SUBJECT: Forwards drawings of mod to resolve essential svcr water single failure issue. Mod allows manual shutoff valves in RHR room & corrects loss of both RHR pumps in one div.

SUSQUEHANNA STEAM ELECTRIC STATION
RESPONSE TO LICENSE CONDITION 2.C.(32)
ER 100450 FILE 841-2
PLA-1656

Docket No. 50-387

Attachment

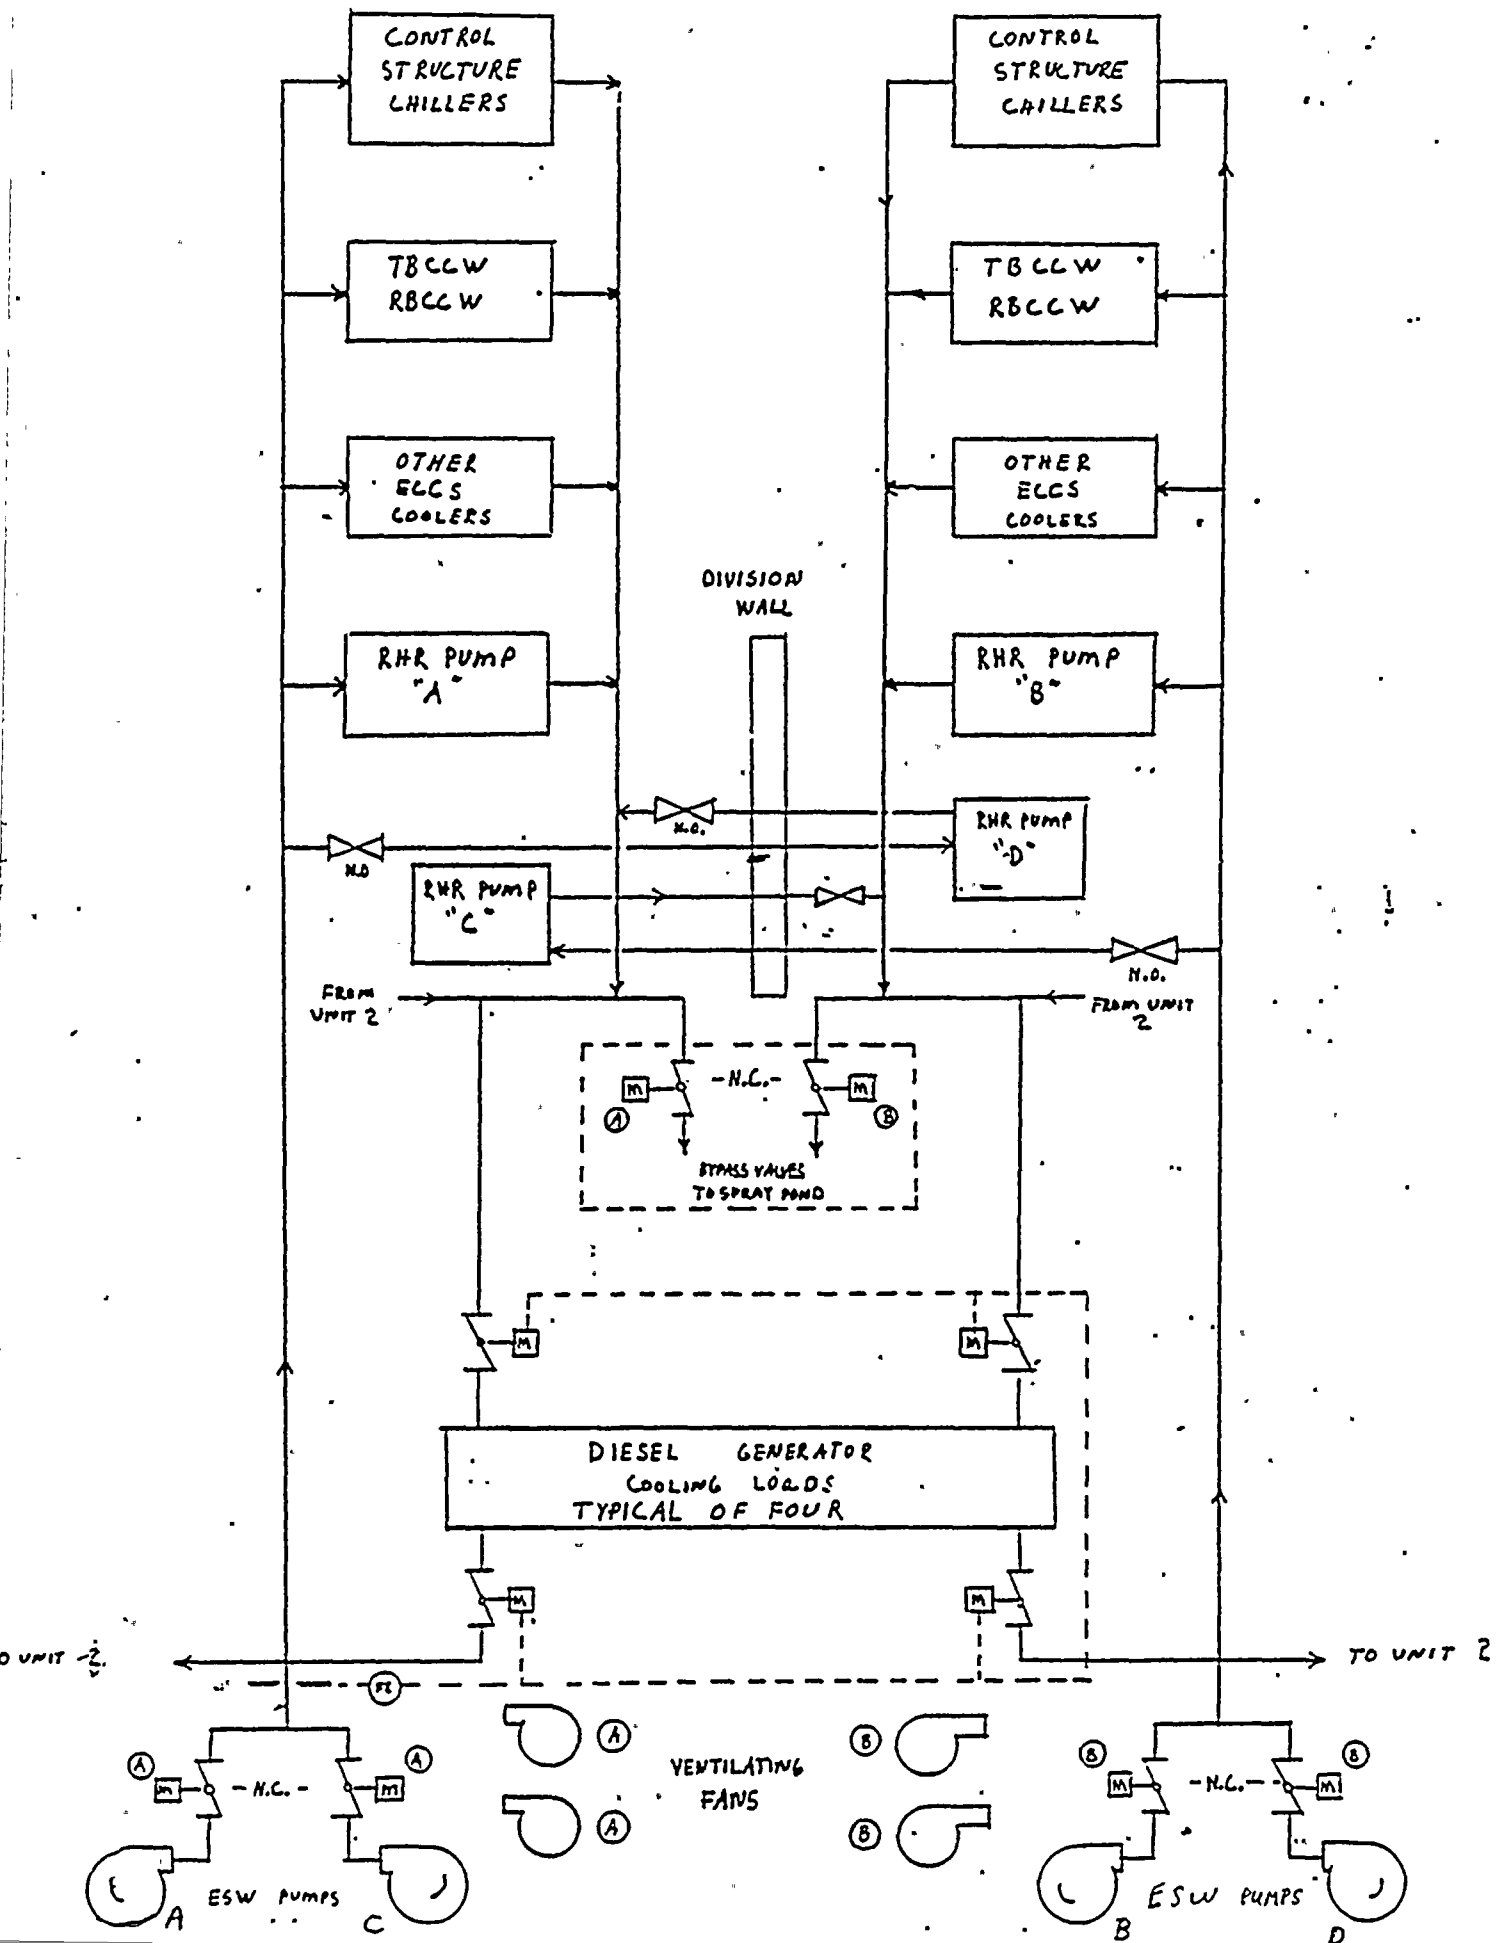
The attached sketch indicates the modification we have chosen as a solution to this problem. Cooling water from the other division of ESW will be repiped to the C and D RHR pump motor oil coolers, seal coolers and room unit coolers. Hence, one loop of ESW will cool one RHR pump in each division, thus allowing the equipment cooling requirements for safe shutdown to be met. This modification also provides manual shutoff valves in the RHR room where the connection to ESW is made.

NEED 2 PUMPS FOR SAFE SHUT DOWN
